**DEPARTMENT OF PLANNING AND ZONING
PLANNER'S REPORT**

DATE: August 14, 2019
TO: Tonya Hutson
FROM: Lynn Patterson
RE: **Design Review – 644 Coleman Street**

The City of Hapeville has received a design review application from Janice M. White to construct a new two-story four bed, three bath single-family dwelling at 644 Coleman Street. The property is currently vacant. The dwelling will have 1,944 SF of heated floor area and will provide off-street parking via a 15' wide driveway along the west side of the house.

SHEET TITLE:
SITE PLAN AND SOIL
EROSION CONTROL
PLAN FOR:

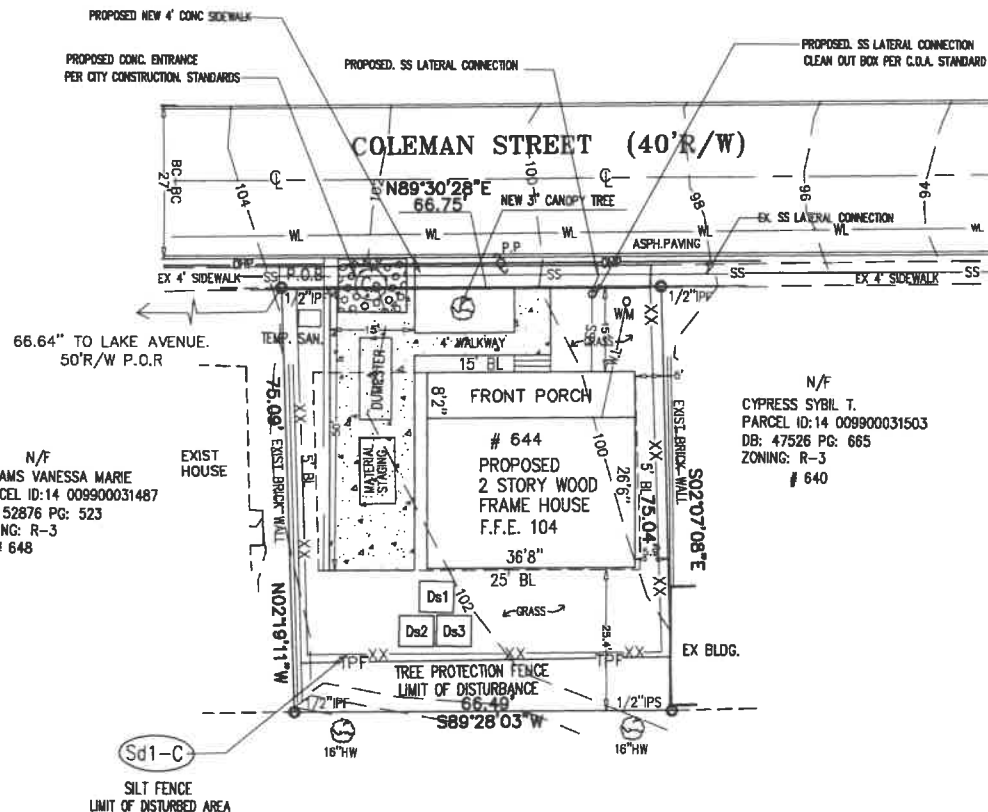
- **The applicant should ensure the new sidewalk includes a landscape zone that conforms with the existing sidewalks on either side of the property.**

- **A minimum of one tree is required every 50' of supplemental area frontage. The property fronts along Coleman for 66.8'. The plans indicate one tree is to be planted. A second tree will be required, spaced so that there is no greater than 50' between the trees.**

Elevation

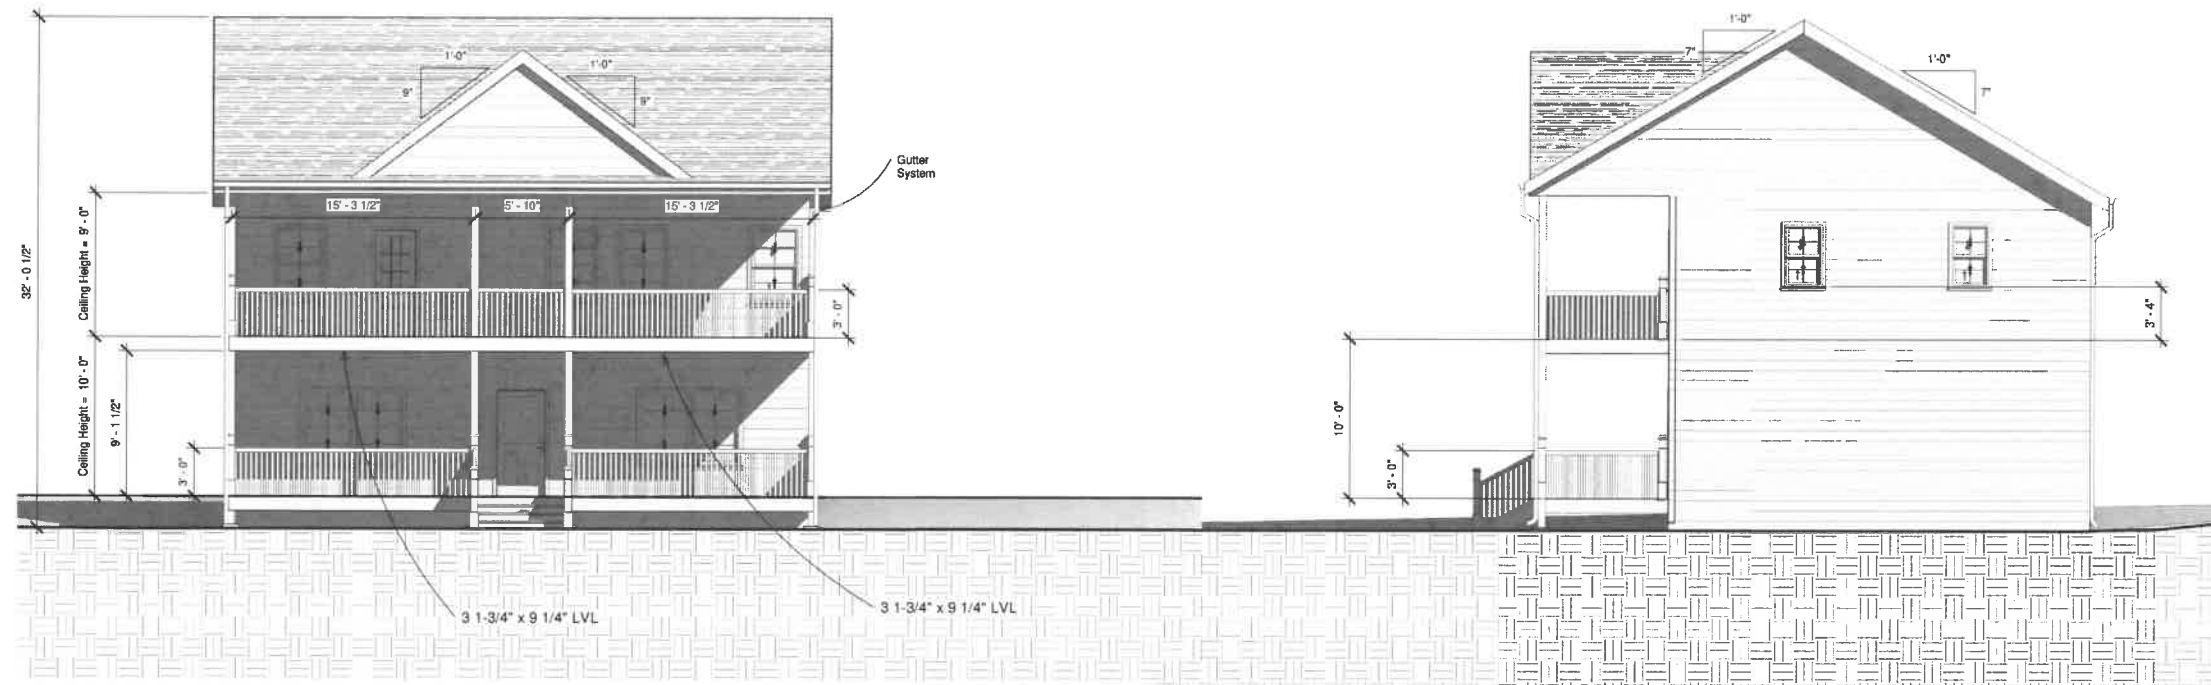
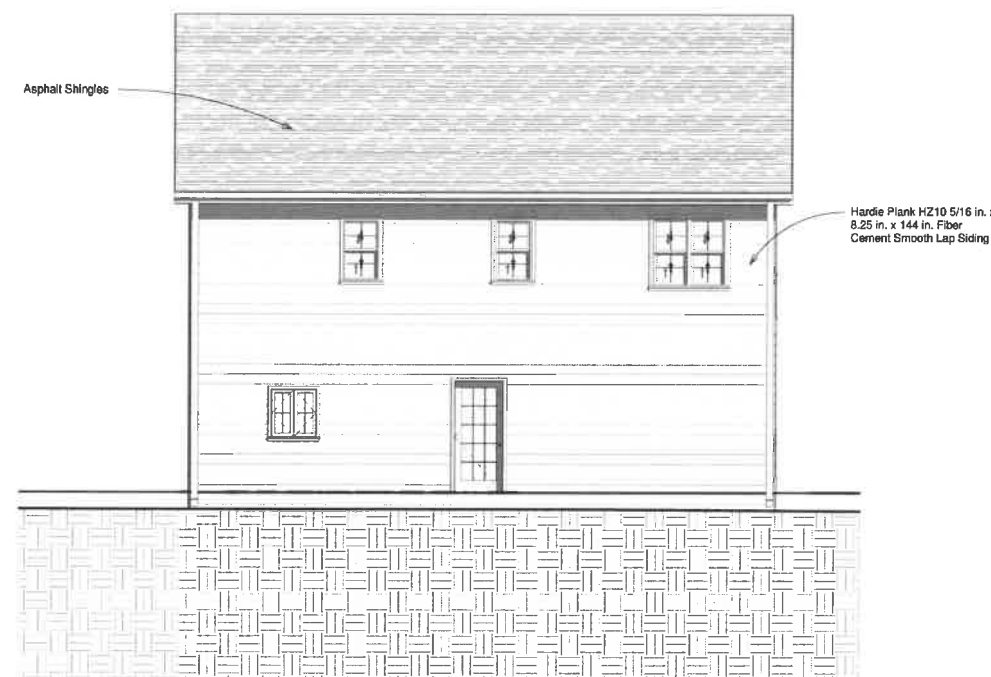
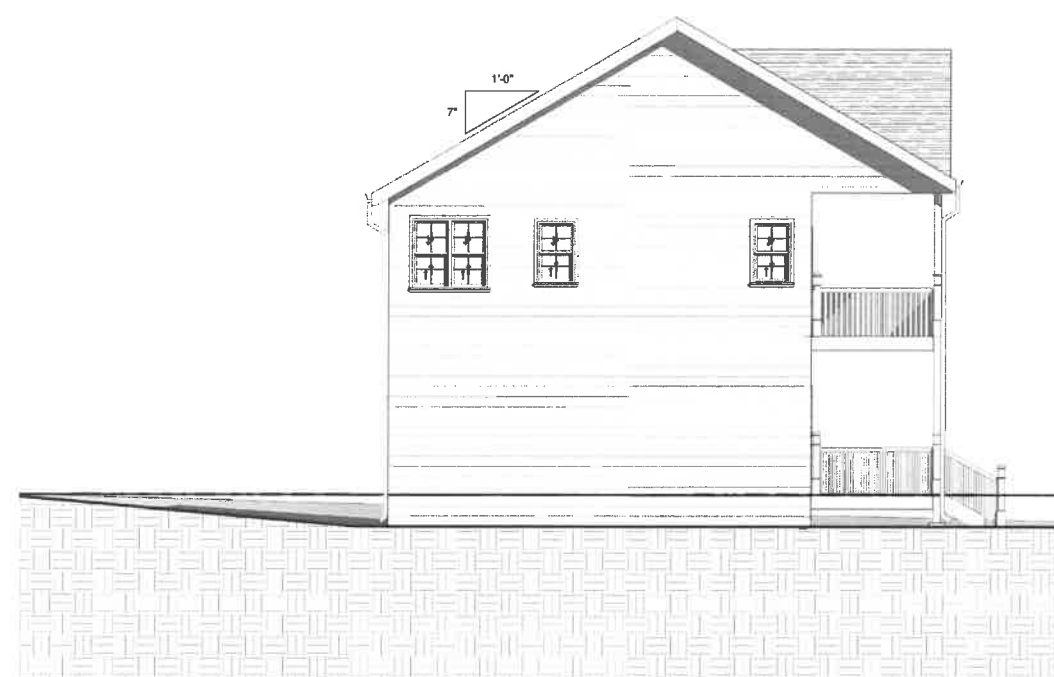
- STAFF COMMENT:**
- Blank, windowless walls are prohibited along all facades. The first floors of both side elevations are windowless, which is not compliant.
 - The top member of the porch railings must be 2x6 wood. Use of a 5/4 board rail cap is not permitted.
 - The porch foundation must be enclosed.
 - The porch and finished first floor must be between 2' and 4' above grade. The applicant should provide the height of the porch and first floor on the plans.
 - Porch columns must be spaced no more than 8' on center. The porch columns are spaced 15' – 2 ½" at their widest point, which is not compliant.

- **The applicant should provide the height of the first story windowsills above the finished first floor, ensuring they are between 2.5' and 3.5' high.**
- **The design does not conform to any of the traditional architectural styles found in Hapeville. The applicant will need to demonstrate the appropriateness of the design for the community and comply with any style changes requested by the Committee.**
